1 INTRODUCTION

This white paper describes proposed changes to NEI guidance for identifying and protecting Balance of Plant (BOP) Critical Digital Assets (CDAs). The changes are intended to improve the efficiency of licensee cyber security programs while maintaining program effectiveness to protect against cyber attacks, up to and including the design basis threat. The described changes affect, and will be incorporated into a future revision to:

Changes to NEI 10-04 and NEI 13-10 Guidance for Identifying and Protecting
Digital Assets Associated with the Balance of Plant

- Appendix A (Figures) page A-1

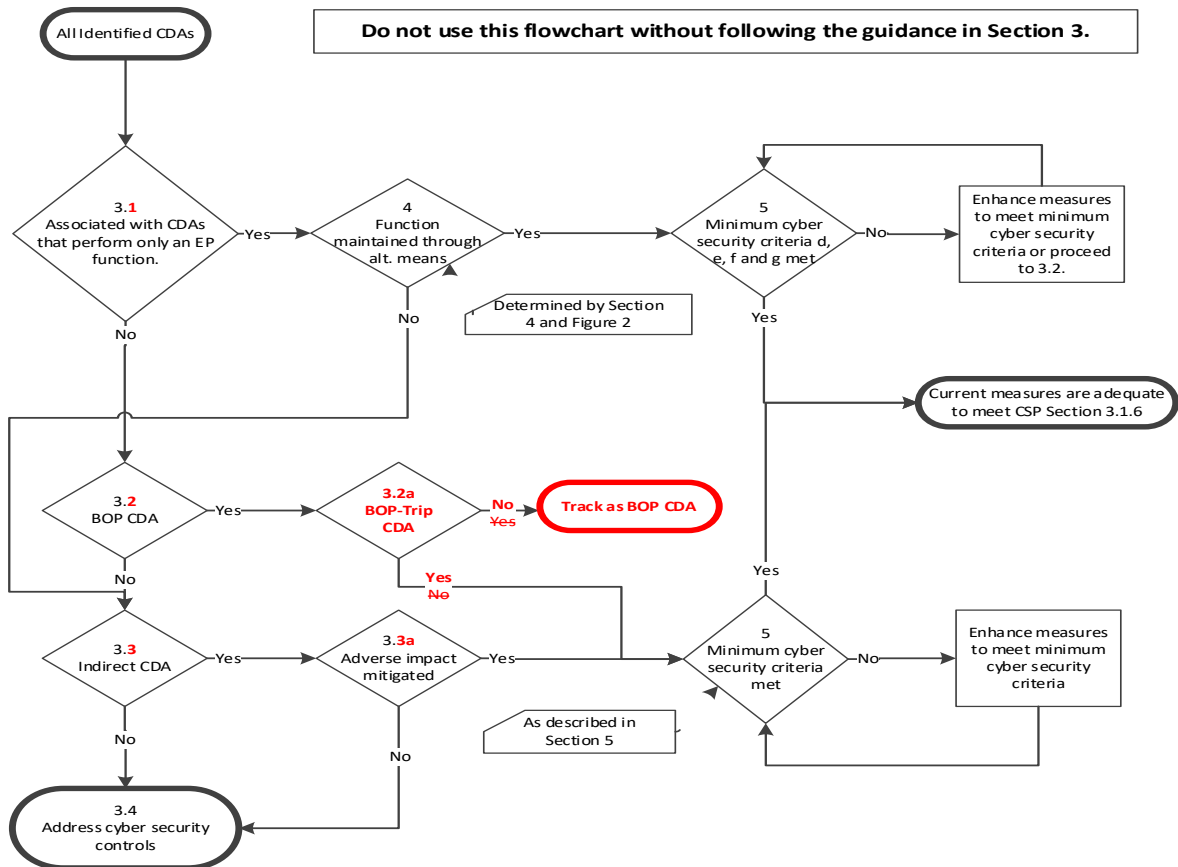
Figure 1 will need to be amended to match the guidance in section 3.1 and 5.

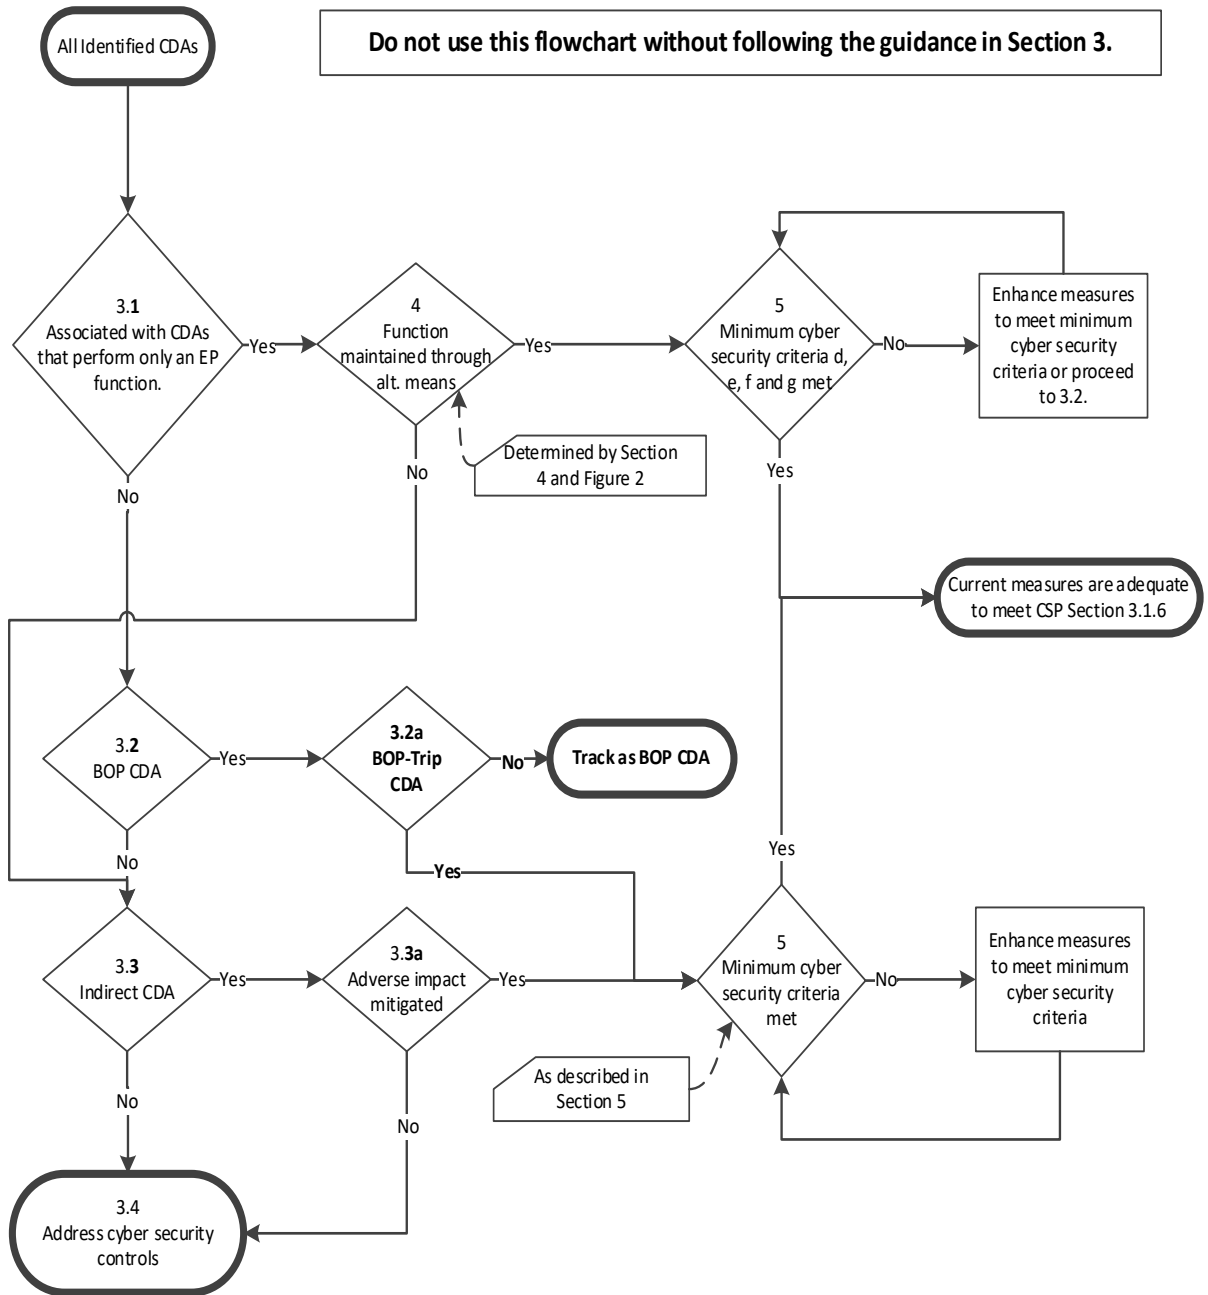
Where a licensee chooses to credit these baseline cyber security controls for an Indirect, BOP-Scram/Trip, or EP CDA, the licensee must confirm these baseline minimum controls criteria are met. EP CDAs may be considered to be adequately protected from cyber attacks if baseline criteria d, e, f, and g are met. A BOP-Scram/Trip CDA or Indirect CDA may be considered to be adequately protected from cyber attacks if all of the following baseline criteria are met:

- a) The CDA, as identified using the analysis set forth in Section 3 of this document, is located within a Protected or Vital Area or the cyber security controls in NEI 08-09, Appendix E, Section E.5 “Physical and Operational Environment Protection,” are addressed.

- b) The CDA and any interconnected assets do not have wireless internetworking communications technologies.
- c) The CDA and any interconnected assets are either air gapped or isolated by a deterministic isolation device. In order to properly fulfill their SSEP function, some non-Direct CDAs are excluded from the requirement to be air gapped or isolated by a deterministic isolation device. These CDAs include but may not be limited to:
